CALL NO. 102
CONTRACT ID NO. 231341
ADDENDUM # 3

Subject: Fayette County, NH 2681 (037)
Letting October 26, 2023

- (1) Revised - Special Note - Pages 69-73 of 302
- (2) Revised - Proposal Bid Items - Pages 292-302 of 302
- (3) Revised Plan Sheets - T21, T77, T80, T82, T85, S006 for Item 28765 & S007 for Item 28766

DECORATIVE FENCE DETAIL

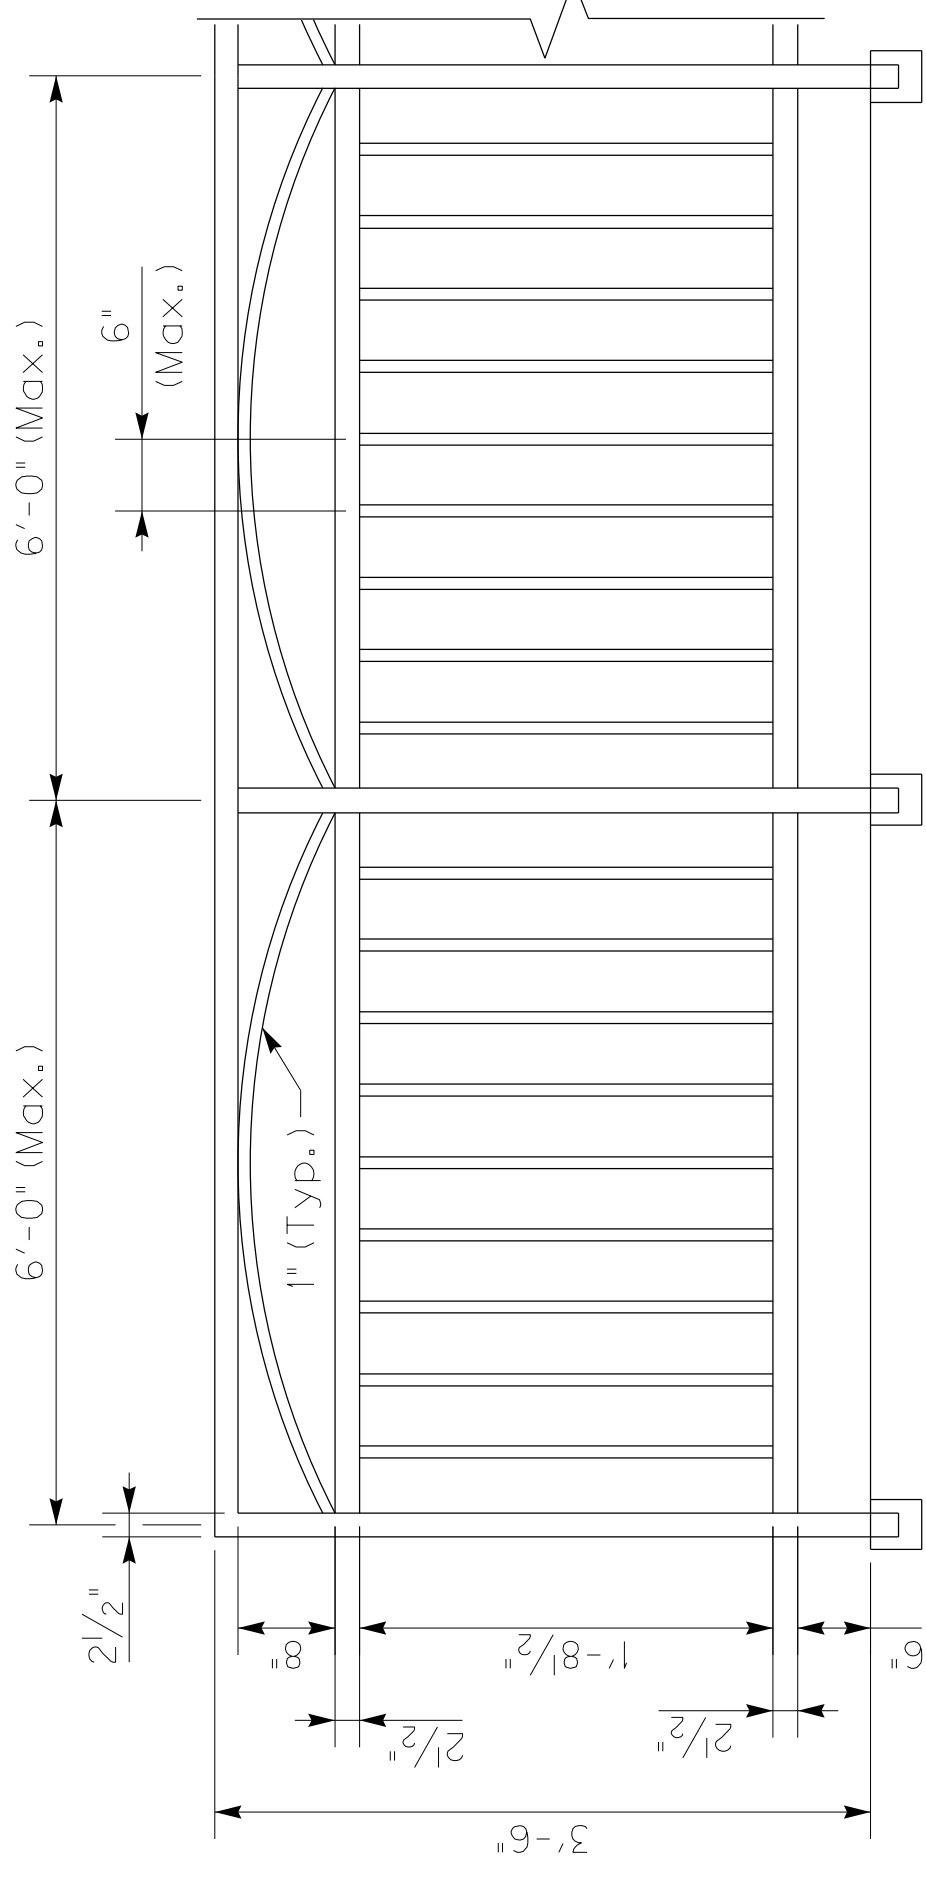
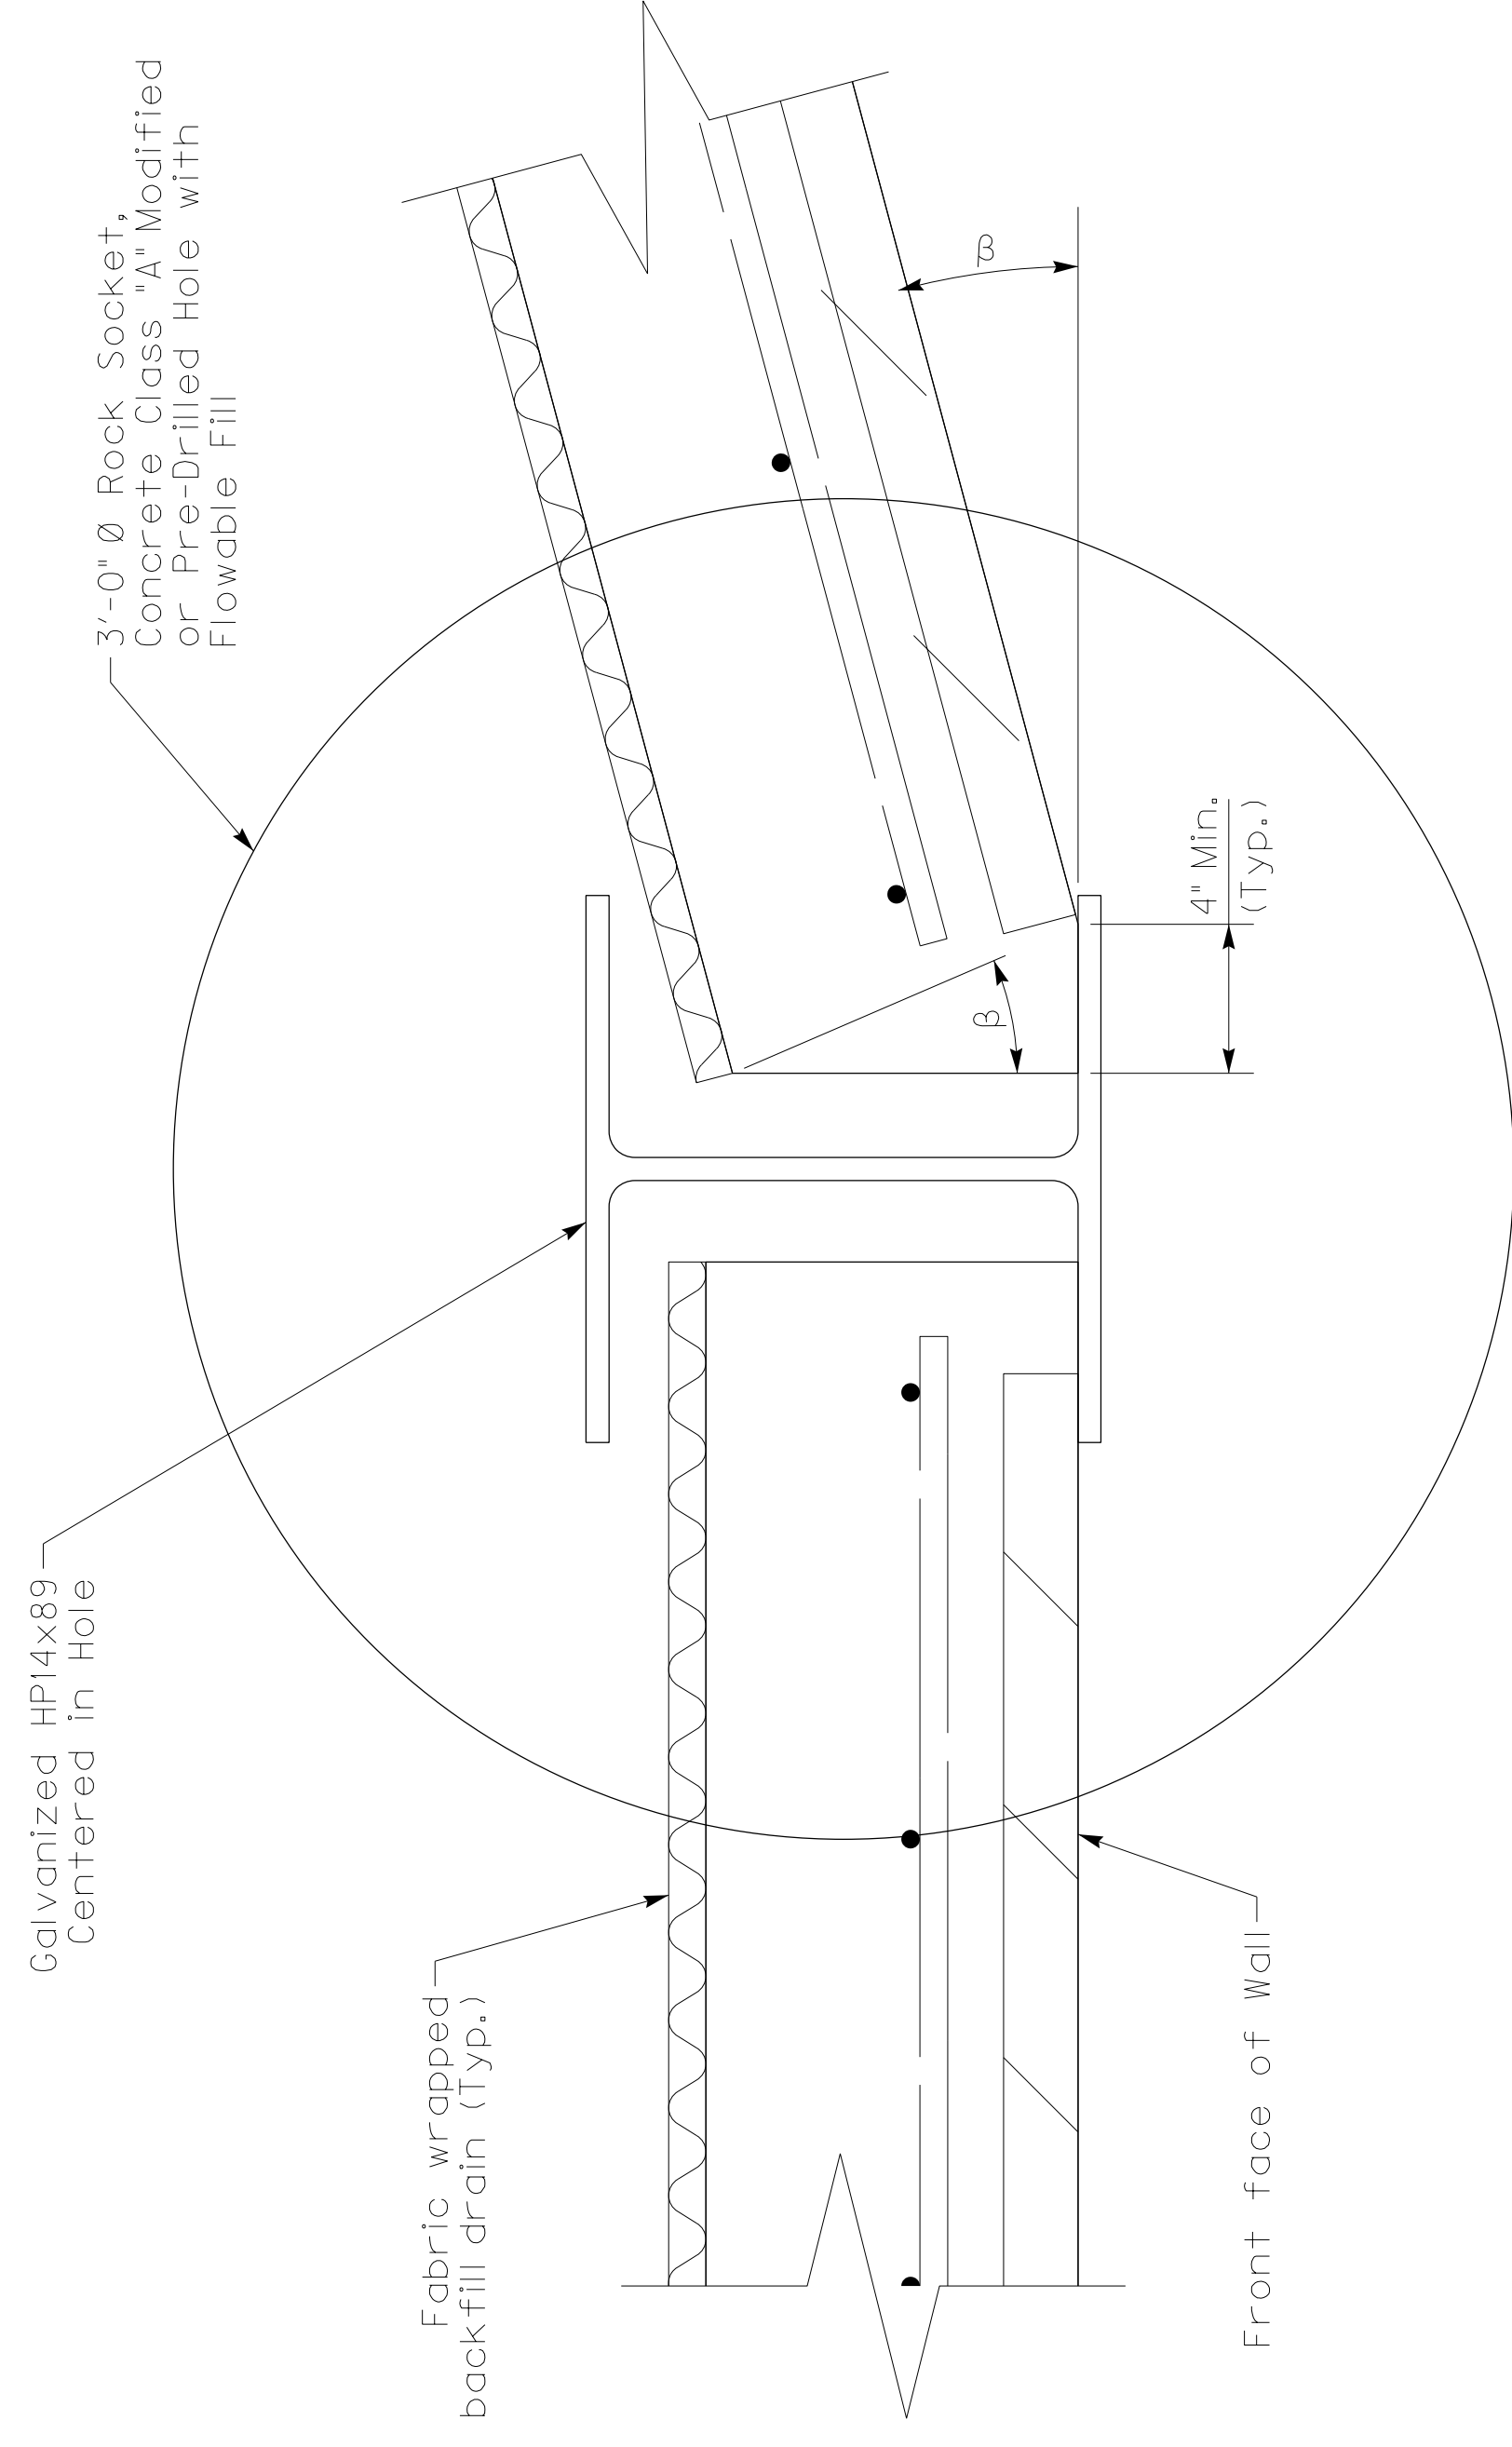
Fence components, internal connections, connection to concrete wall, and additional design parameters are the responsibility of the contractor. Ensure the design meets all applicable requirements of the AASHTO LRFD Bridge Design Specifications, 9th Ed.

Design calculations and plan details for the fence components, internal connections, and connection to concrete wall shall be prepared and sealed by a Professional Engineer licensed in the Commonwealth of Kentucky. These shall be submitted to the Engineer for approval. Fabrication and installation shall not commence prior to approval. All labor associated with this shall be considered incidental to the unit bid price for the decorative railing.

The fence components and connections shall be steel and shall be powder coated. After galvanization in accordance with the manufacturer's recommendations. The contractor will be required to provide and test multiple color options for final approval by the Engineer. Fence components and coating shall include a 10-year warranty. All labor and materials associated with this shall be considered incidental to the unit bid price for the decorative railing.
